Facility Name: City of Del Rio Landfill

Re: Response to Technical Notice of Deficiency (NOD)
City of Del Rio
Del Rio, Val Verde County, Texas
Proposed Municipal Solid Waste Permit No: 207C
Tracking No. 29656107; RN102143294/CN600756290
Permit Major Amendment Application

Technical NOD #3

MAJOR PERMIT AMENDMENT APPLICATION PART I

Appendix IIIH-C. Channel and Pond Design

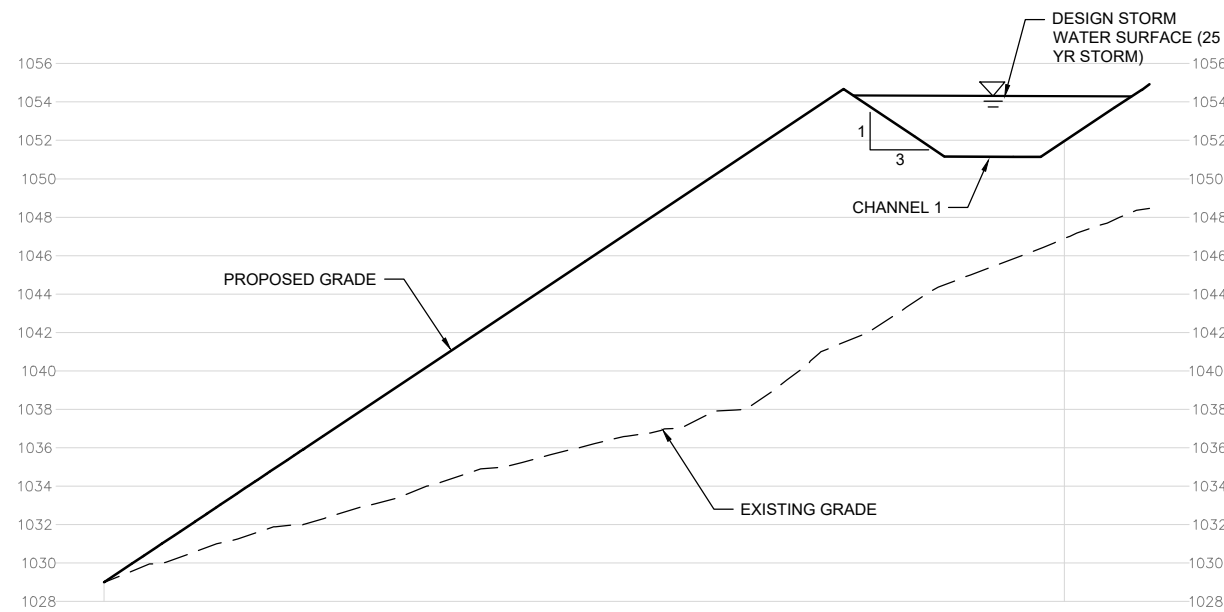
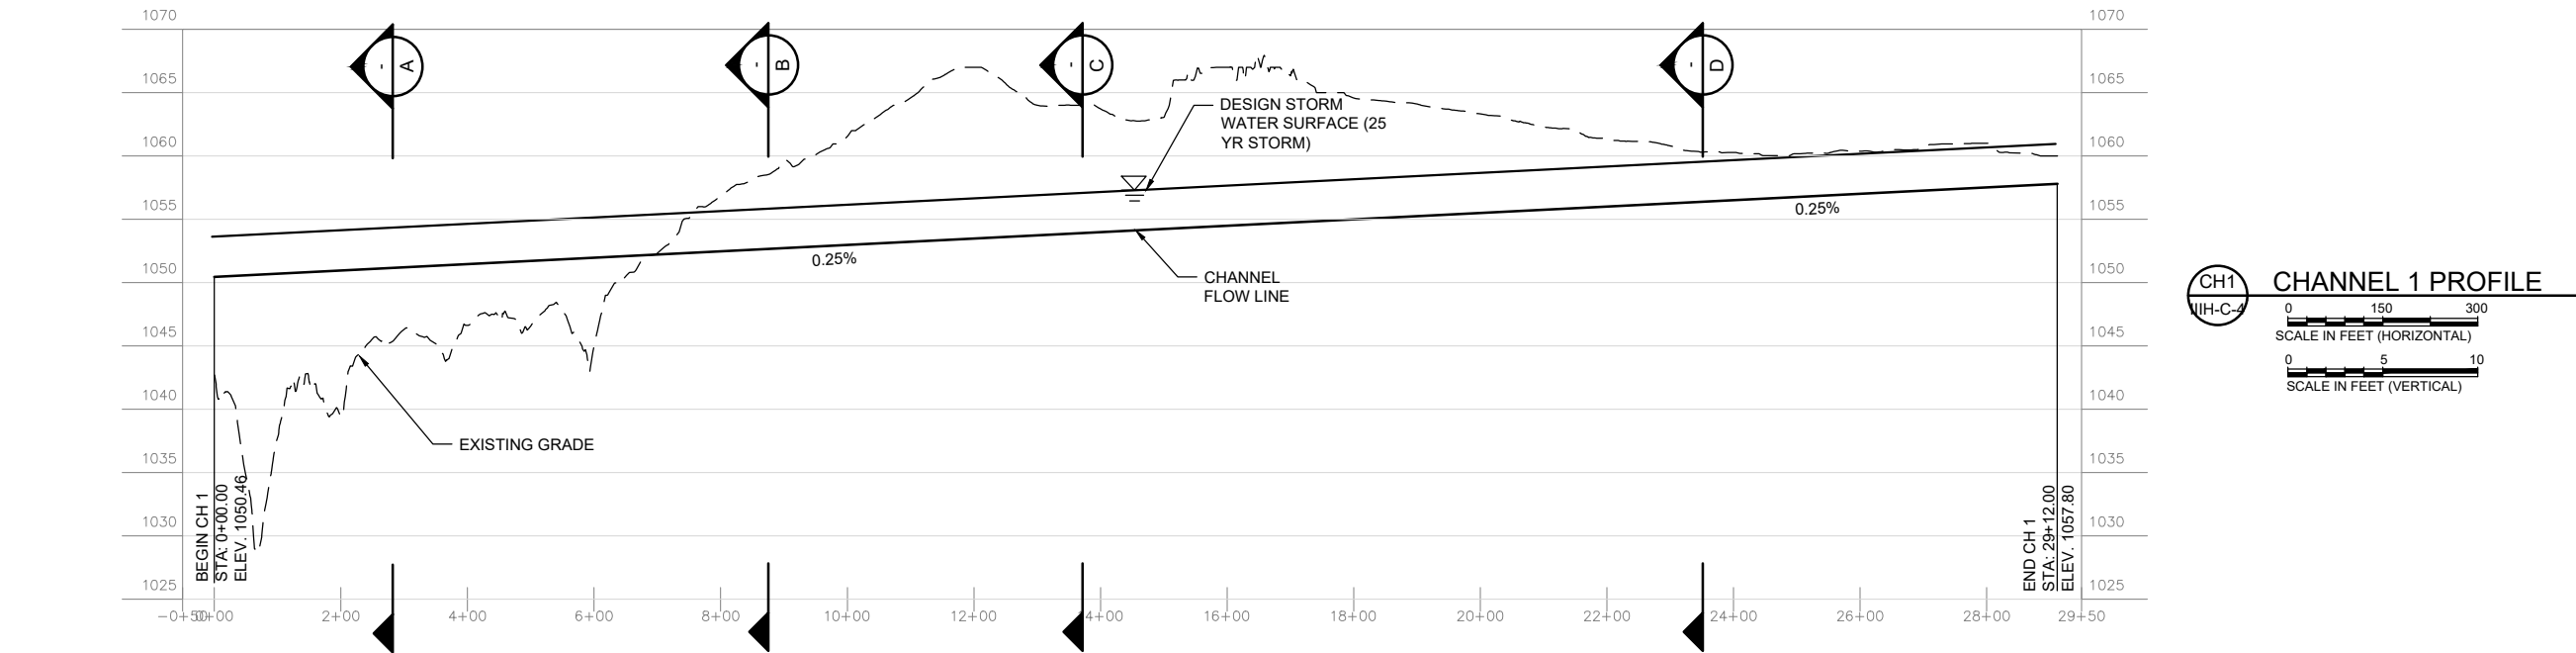
T6	306	Part III	330.305(c)(1)(B)	Appendix IIIH	Incomplete	Comment: The response to Comment T17 of the second NOD states that the cross-sections for Channel 1 and other channels are provided. The cross-sections for Channel 1 could not be located within the application. Revise to provide the cross-sections for Channel 1. Response: Cross Section has been provided.
T7	359	Part III	330.331(a)(2)	SDP pg8, IIIA-1	Incomplete	Comment: 1) The response to T18 of the second NOD states that pages were updated (including IIIC-A-4, IIIC-A-5, IIIC-A-31 to IIIC-A-37, IIIC-A-69 to IIIC-A-75). The listed updated pages could not be located within the application. Provide the updated pages. 2. Pages IIIC-A-3 and IIIC-A-3 were revised to state that the site is modeled using hydraulic conductivity of 1×10^{-5} cm/s for conservative design. To prevent any misunderstanding, revise to clarify for which aspect(s) of the landfill design the use of 1×10^{-5} cm/s is deemed conservative design. 3. Revise the last sentence on Pages IIIC-A-3 and IIIC-A-3 by inserting “cm/s” after “1×10^{-5}” or specify the appropriate unit. Response: 1. The HELP models were reviewed but ultimately decided to retain the versions included in the original application. These original HELP models represent a more conservative design, as they use a lower hydraulic conductivity value for the infiltration layer. The pages noted as not being included in the 2nd NOD response (IIIC-A-4, IIIC-A-5, IIIC-A-31 to IIIC-A-37, and IIIC-A-69 to IIIC-A-75) are associated with the HELP models. Since the models were not revised, these pages were intentionally excluded from the submittal. They were mistakenly listed as revised in the response letter; however, no changes were made to these pages. The pages included in NOD 1 are current. 2. Pages IIIC-A-3 and IIIC-A-3 have been revised to clarify that 1×10^{-5} cm/s provides a conservative design for the infiltration layer. 3. The appropriate unit has been specified on Page IIIC-A-3.
